RFP 2021-10

**REQUEST FOR PROPOSALS
FOR
CONTRACT NO. 2-FACILITY IMPROVEMENTS,
GENERAL CONSTRUCTION
AT THE
MATERIALS RECOVERY FACILITY
IN
HILLBURN, NEW YORK**

DATE: JULY 23, 2021

SUBJECT: ADDENDUM NUMBER 6

Architectural:

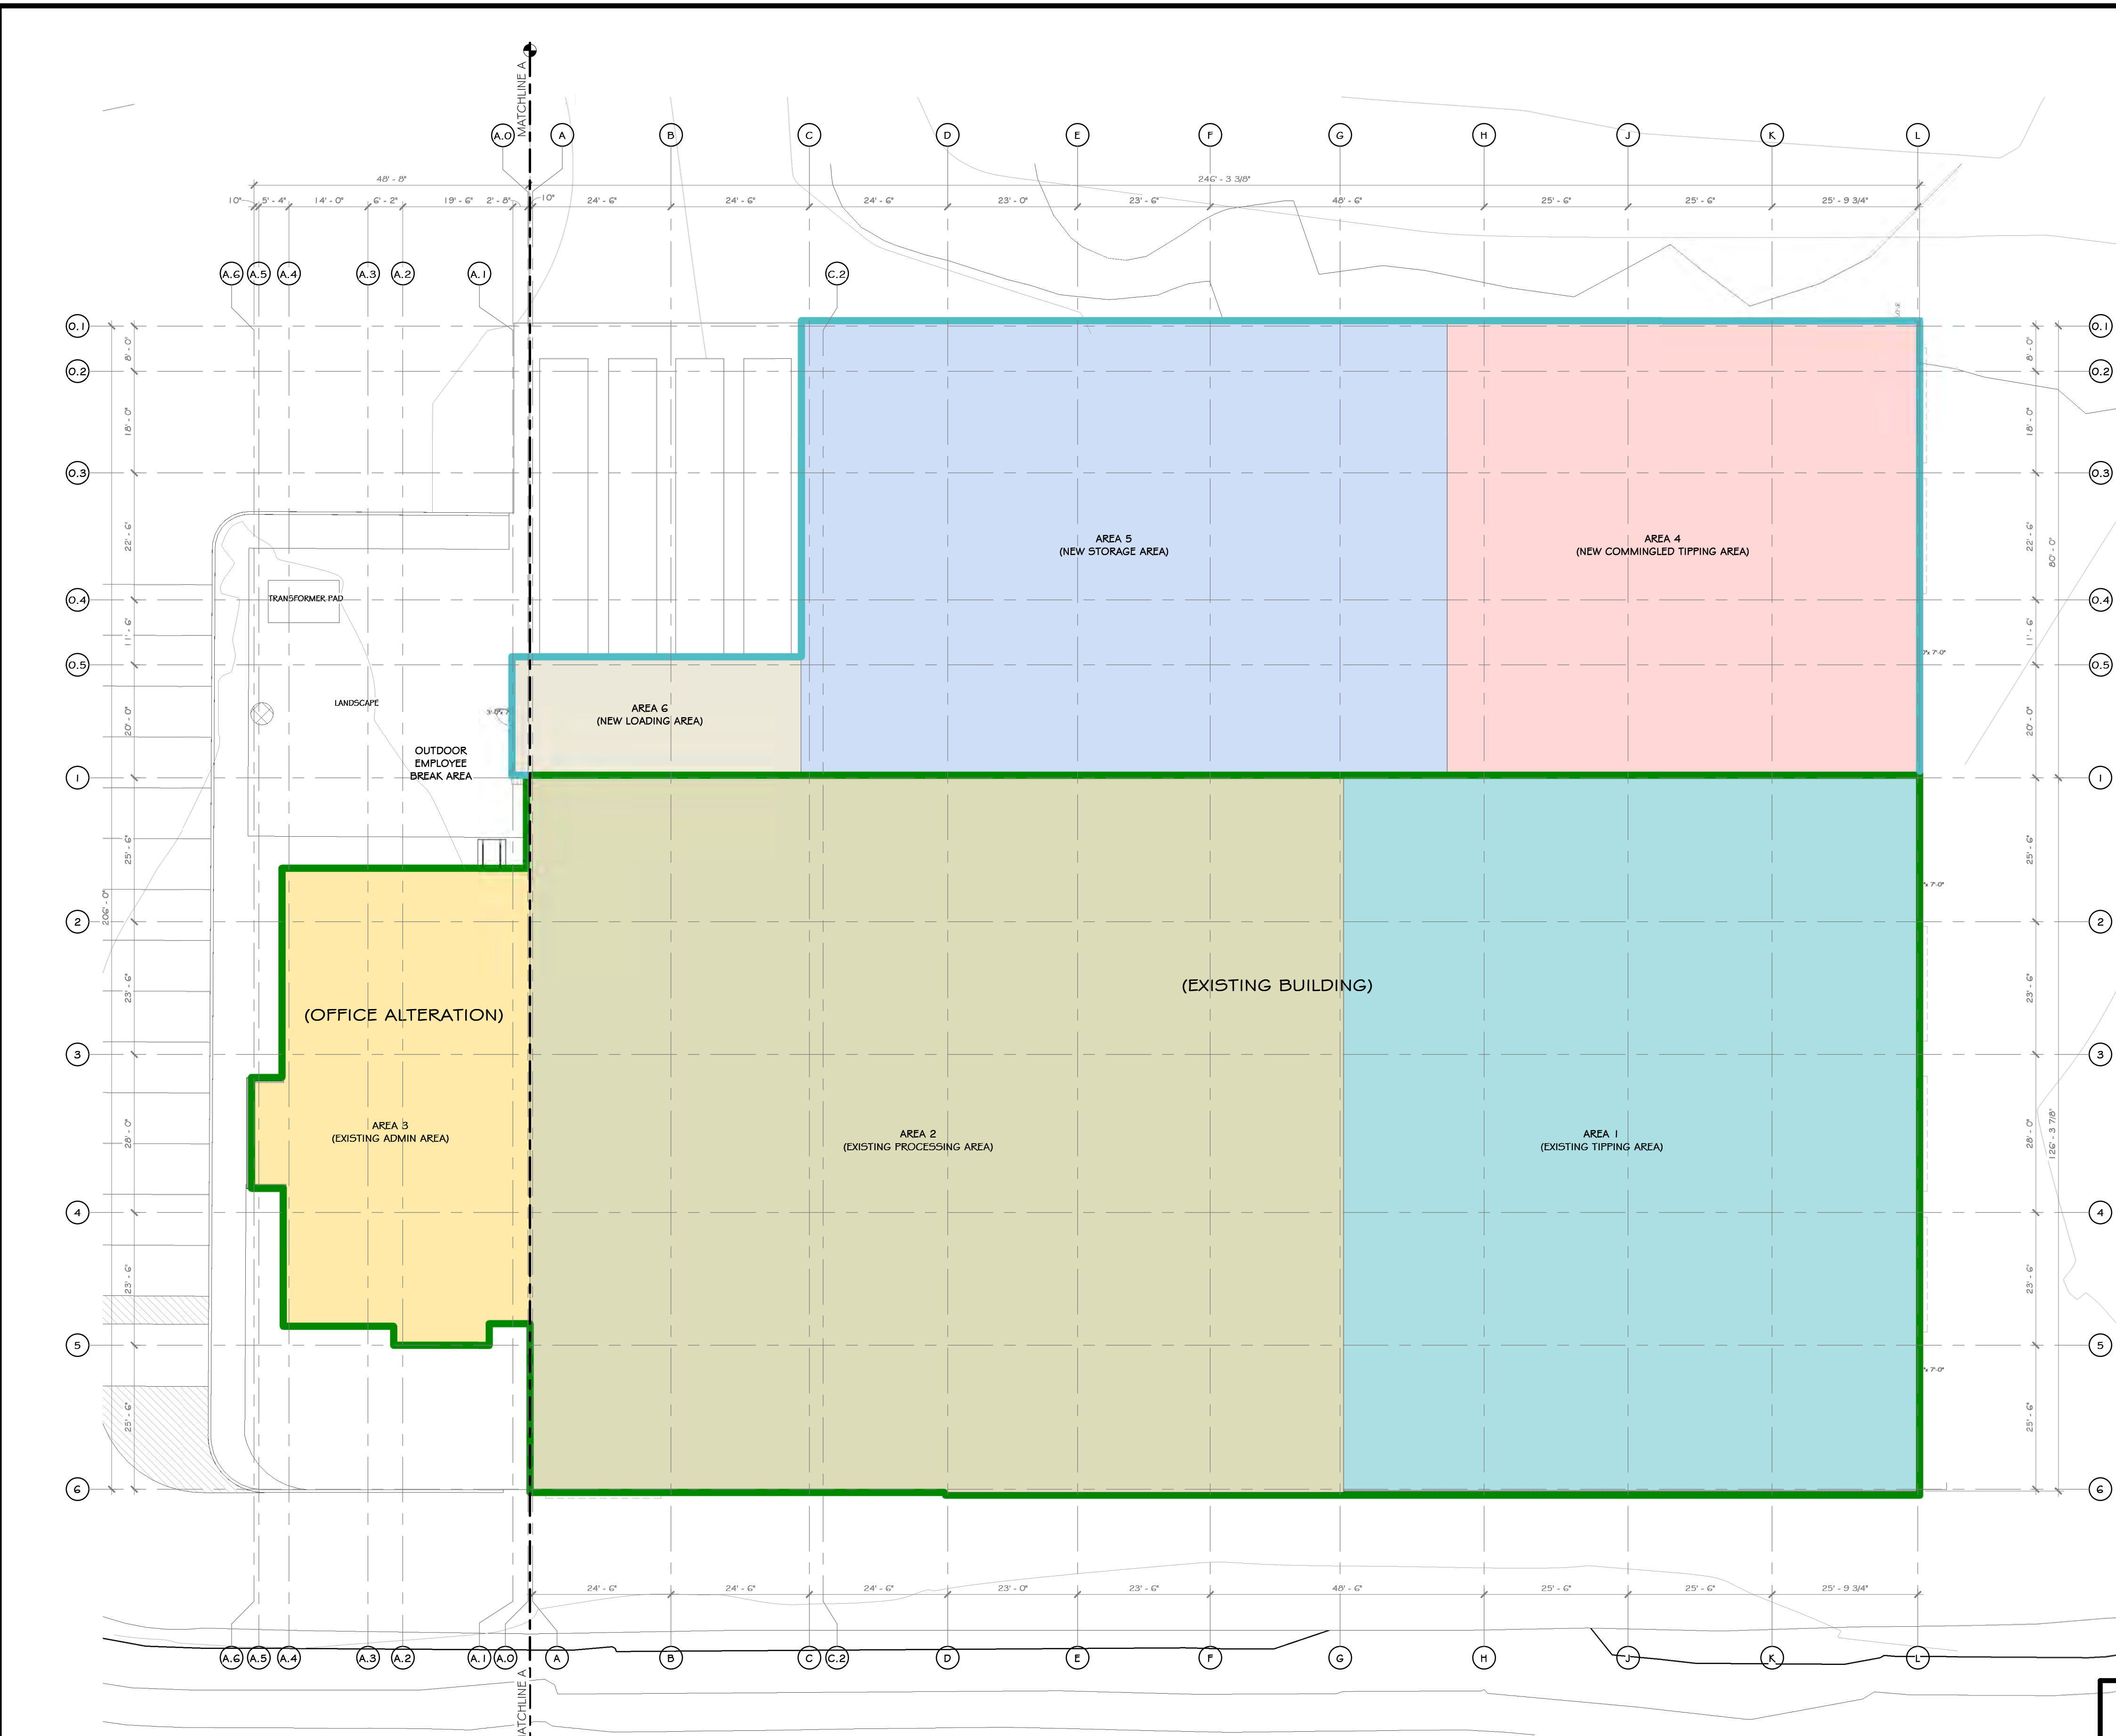
1. Note added to provide new gutters and leaders.
2. Provide new vinyl tile flooring in elevator.
